## **NHTSA ODI – EA09-009**

- The information that follows was prepared to supplement the Mack Trucks presentation and technical discussions on the subject during a review meeting December 17, 2009
- Attendees were from NHTSA, Mack Trucks, Haldex and Meritor WABCO
- For further information, see individual vehicle and product reports to be submitted to NHTSA in January, 2010.

## Relay Valve Exhaust Seat / Modulation Tube Design Change – Phase I

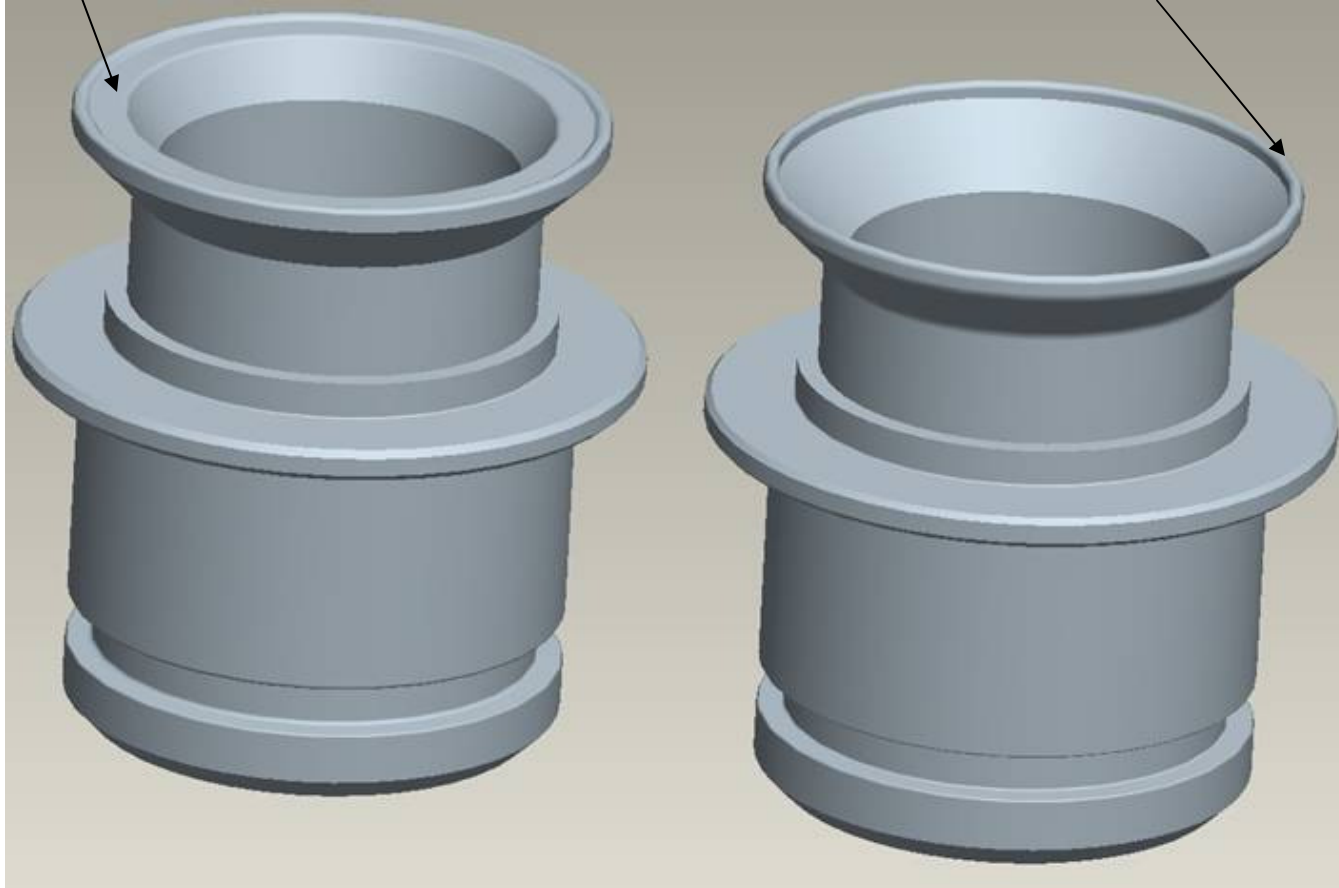
Phase 1 Implemented Jan 2009

(Additional metal to reduce rubber deflection)

Original Design

(No metal stop other than seat – results in more rubber deflection)
